# Product/Process Change Notice (PCN)

PCN #: PCN\_WE-STAR-  
TEC\_20171101\_74271131(S)\_Capacity Increase

Product Affected: 74271131, 74271131S

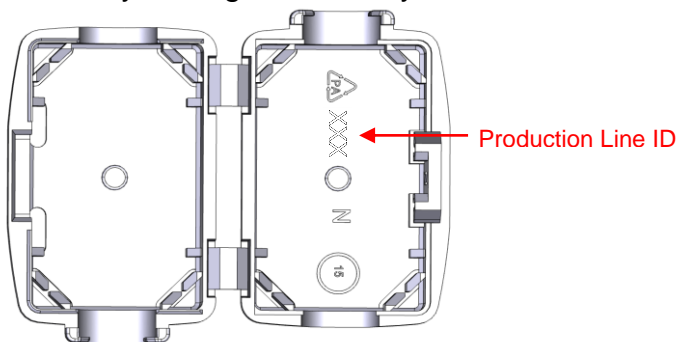
In order to increase the production capability Würth Elektronik will implement another production line for the plastic housing.

1. Neither electrical nor mechanical properties of the part will be changed.
2. The production lines can be identified by the three digits inside the plastic housing.

### Already established production lines of plastic housing:

Digits: 128

Country of Origin: Germany

Digits: 312

Country of Origin: Austria

### Additional production line of plastic housing:

Digits: 375

Country of Origin: Germany
